AUSTRALIAN WAR MEMORIAL DEVELOPMENT PROJECT

RESPONSE TO PUBLIC SUBMISSIONS

SEPTEMBER 2020

Image 2: ETFE based Glazed Link

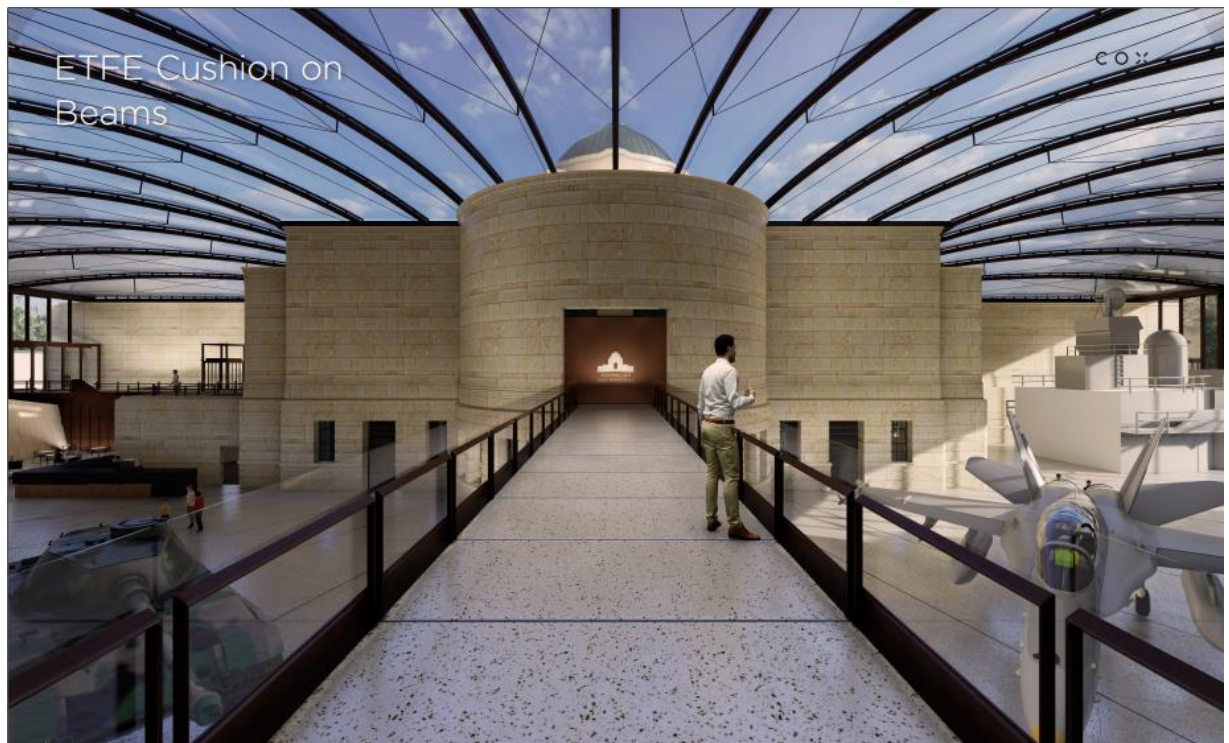
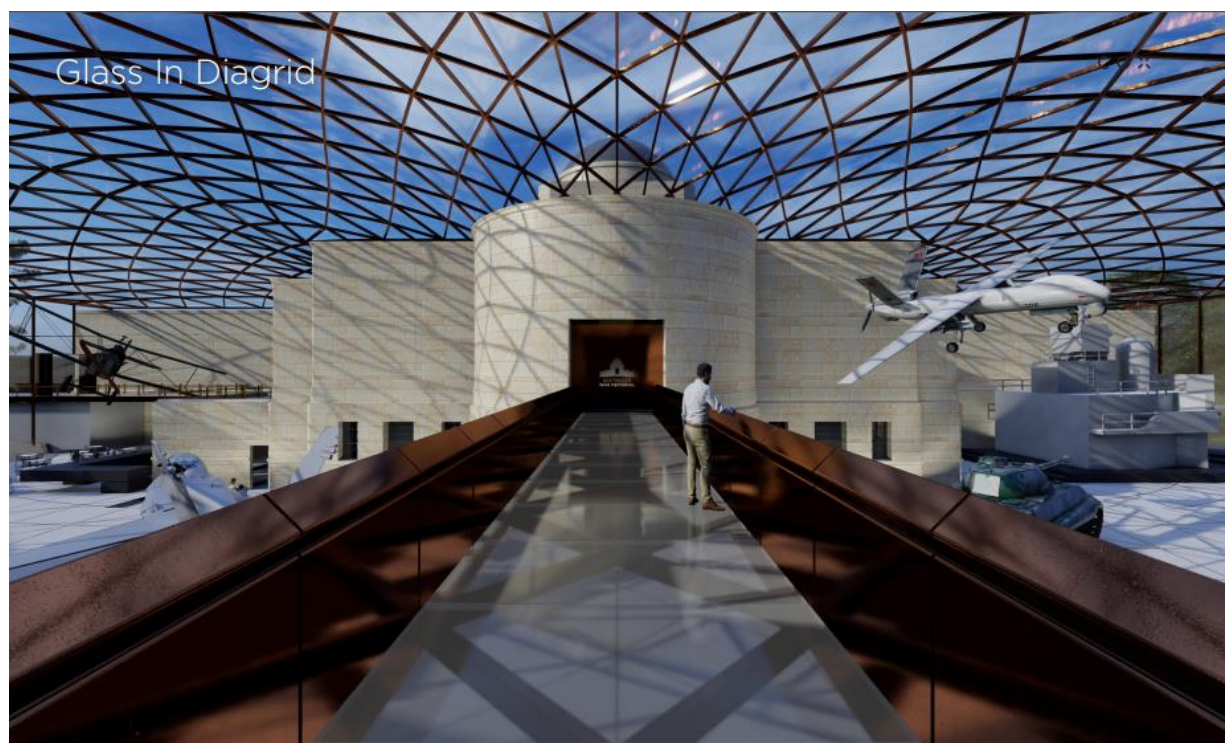
107; 112; 127	S7.3.4	APH Vista –Glazed Link above the parapet	Three public comments were received regarding this section of the Preliminary Documentation. Each noted, to varying degrees, the impact of the visibility of the Glazed Link above the parapet of the Main Memorial Building and the consequent impacts on the silhouette of the Memorial and on the Parliament House Vista more generally.	<p>The Memorial has accepted this feedback and has modified the proposed Glazed Link to better account for this impact.</p> <p>The Memorial has also consulted extensively with DAWE on these changes to account for comments on this impact.</p>
---------------	--------	--	---	---

ETFE also offers acoustic advantages that will be particularly important in allowing the Memorial to use this space for education and public programs.

In sum, these qualities make it ideal for use in the Memorial's proposed Glazed Link.

Figure 4: Parade Ground design resolution

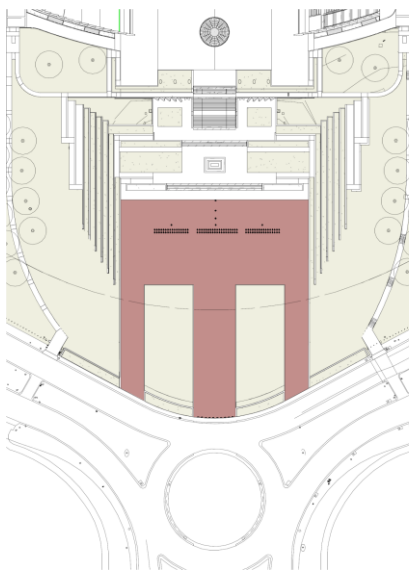
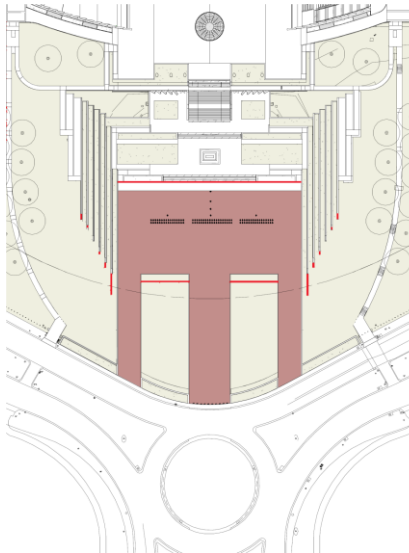
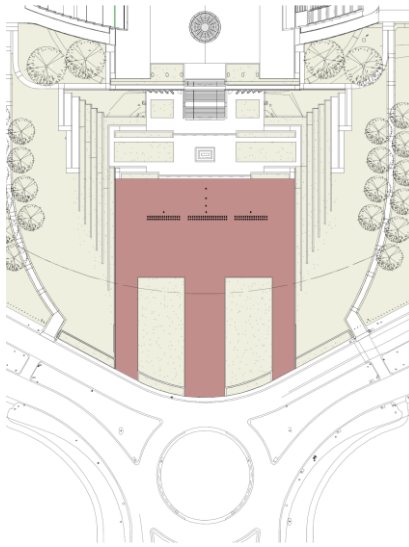
036; 127; 135; 138	S7.5.2	Public Realm – Parade Ground Orientation	Four submissions expressed specific concerns with the proposed Parade Ground re-orientation on the basis that the change was unnecessary or detrimental.	<p>The Memorial acknowledges that, not unusually, views on the changes to the Parade Ground vary including the opinions proffered through these comments that view the changes as less preferable to current arrangements.</p> <p>The Memorial has consulted with relevant stakeholders and authorities as part of this proposed design change and believe it to be the best outcome for the project and the Memorial.</p>
--------------------	--------	--	--	--

In response to specific concerns around the increased size of the parade ground the Memorial has undertaken further detailed design and resolved to reduce the parade gravel area by 3m in the north / south direction. The area of overall gravel is now near equivalent to the existing gravel area. The length of the sandstone terraces has also been reduced, with the lower terrace now ending in line with the grass and the upper rows reduced back accordingly. More (temporary) informal seating on the grassed area will be utilised for commemorative events.

The figure below shows the July 2020 (top) and September 2020 (bottom) parade ground designs, the changes are highlighted in red in the middle image. Larger images are provided in the Final Preliminary Documentation.
